# DEPARTMENT OF PLANNING JEFFERSON PARISH, LOUISIANA

## DESIGN REVIEW REPORT

<b>DOCKET NO:</b> CPZ-66-16	<b>ADVERTISING DATES:</b>	11/30/16 12/07/16 12/14/16
<b>SUMMARY NO.:</b>		
<b>COUNCIL DISTRICT:</b> 5: Jennifer Van Vrancken	<b>PAB PUBLIC HEARING:</b>	12/22/16
<b>COUNCIL AT LARGE:</b> A: Christopher L. Roberts B: Cynthia Lee-Sheng	<b>COUNCIL HEARING:</b>	
	<b>LAST MEETING DATE FOR COUNCIL ACTION:</b>	04/05/17

Variance to the attached sign regulations of the CPZ Commercial Parkway Overlay Zone

FIGURE 5

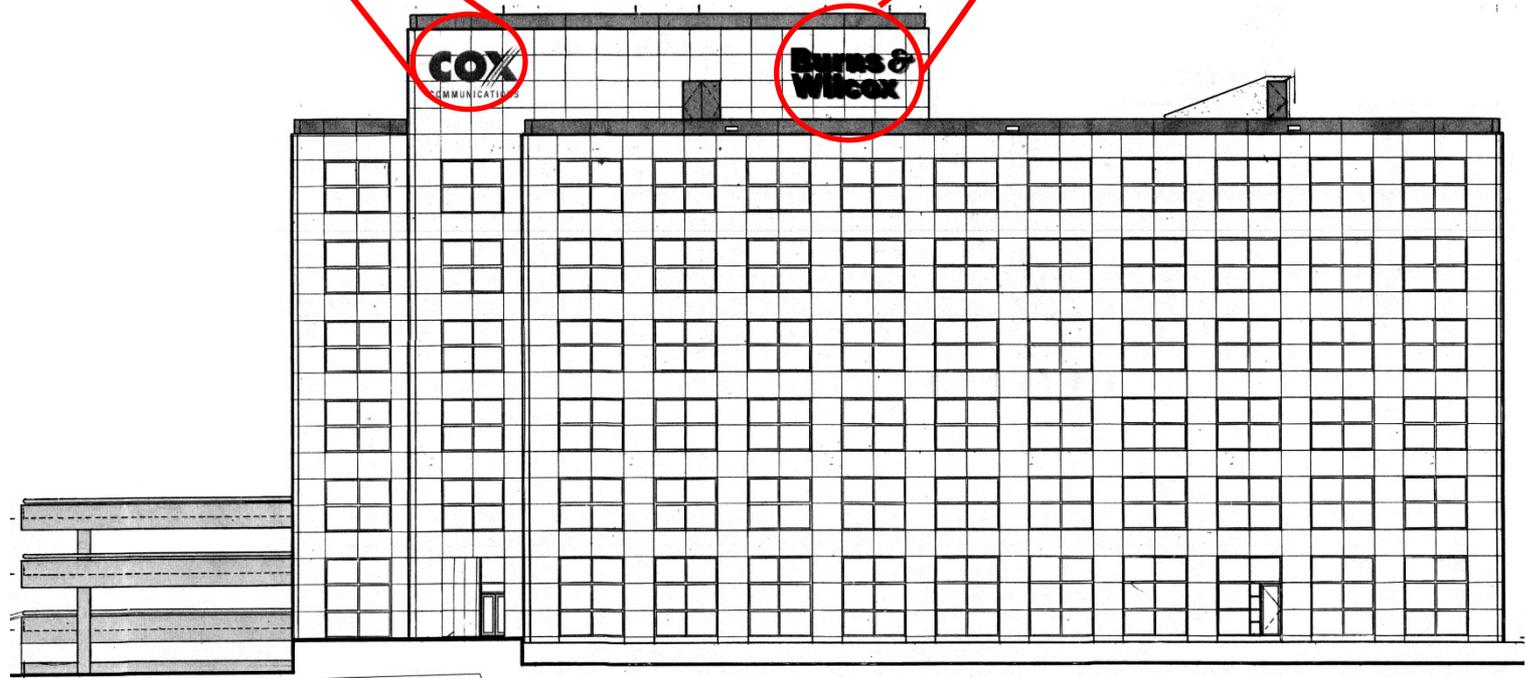
3. The applicant now proposes two additional attached signs, one on the western-side facade and one over the building's main entrance, each at 72.7 sq. ft., for a total sign area of 233.4 sq. ft. including the existing Cox sign (Figures 5 & 7).

**ICE - Building** is **OPPOSED** to this Case for the following reasons: 1. Only (1) attach sign per use is allowed as per Sec. 40-477 (b)(1). Proposed plans show an existing sign and 2 new signs. 2. The total allowable sign area as per Sec. 40-477 (b)(1)(a)(1) is 300 square feet. Proposed total signage including existing sign is 331 sq. ft. Existing Monument Sign not included in this review.

**FIGURE 7**

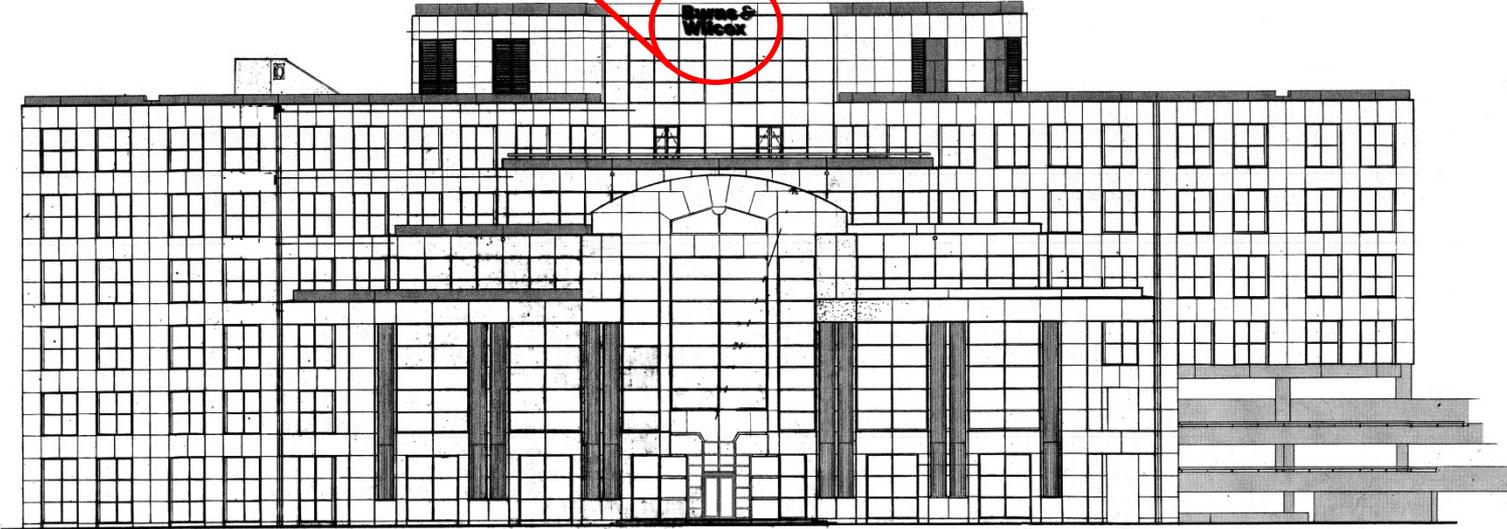
5. Section 40-480 states that variances to the CPZ requirements may be granted provided the following criteria are met (Figures 6 & 7):
  - a) *The proposal complies with CPZ requirements to the maximum extent possible and taking into account space limitations of existing structures.* The proposal is not necessitated by any space limitation affecting the existing structure.

- d) *Special conditions and circumstances exist peculiar to the land, structures or buildings which are not applicable to other land, structures, or buildings in the same zone.* The building is not parallel with Airline Dr., thus limiting visibility of the front façade sign to westbound traffic on Airline Dr.
